Subject: MHI's Responses to US-APWR DCD RAI No. 212-1950

Responses to Request for Additional Information No. 212-1950,
Revision 1

**US-APWR Design Certification
Mitsubishi Heavy Industries
Docket No. 52-021**

RAI NO.: NO. 212-1950 REVISION 1
SRP SECTION: 03.07.02 – Seismic System Analysis
APPLICATION SECTION: 03.07.02
DATE OF RAI ISSUE: 02/25/09

Fig.19.4 Comparison of ISRS for NASTRAN and ANSYS FE CIS models (EW Direction)
 (Sheet 5 of 5)

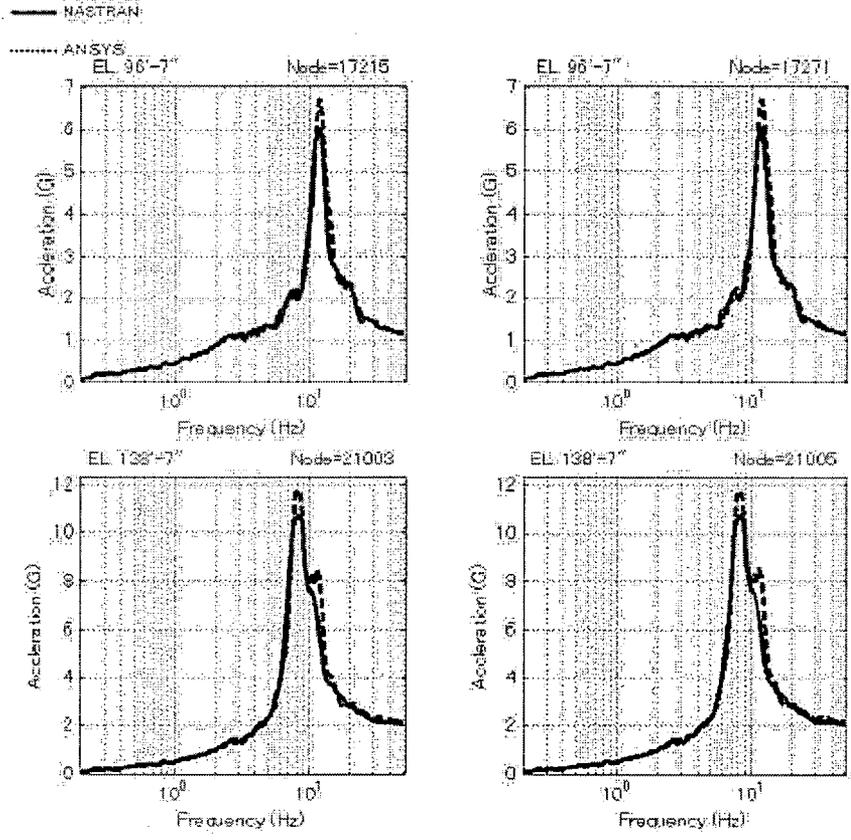
In Section 3.7.2.3.1 of the DCD it is stated that the NASTRAN finite element models are used for validation of the dynamic lumped mass stick models and the NASTRAN results are validated by comparison to the results of separate ANSYS finite element model analyses. Provide results and details of the NASTRAN and ANSYS validations. Describe how the various finite element models that were developed for validation meet the guidelines of SRP Sections 3.7.2.II.3.C.ii and iii.

To verify whether the dynamic properties of the NASTRAN FE model conform to those of the ANSYS FE model, the 5% damping ISRS are calculated at several node points in both models that represent main floor levels. The points selected for validation are shown in Figures 19.1 and 19.2 (below) and Tables 19.1 and 19.2 (below) which are the same points selected in Subsection 3.7.2.3.10 of the DCD.

As stated in the response to question RAI 3.7.2-8 of this RAI, ISRS which incorporate the effects of local vibration modes will be provided in Revision 2 of the DCD. The revision will meet the guidelines of SRP Section 3.7.2.II.3.C.iii.

Further results and details of NASTRAN and ANSYS FE model validations will be provided in Revision 2 of the DCD. The response previously submitted for RAI 212-1950, Question RAI 3.7.2-8, states the ISRS, considering local vibration modes, will be provided in Revision 2 of the DCD.
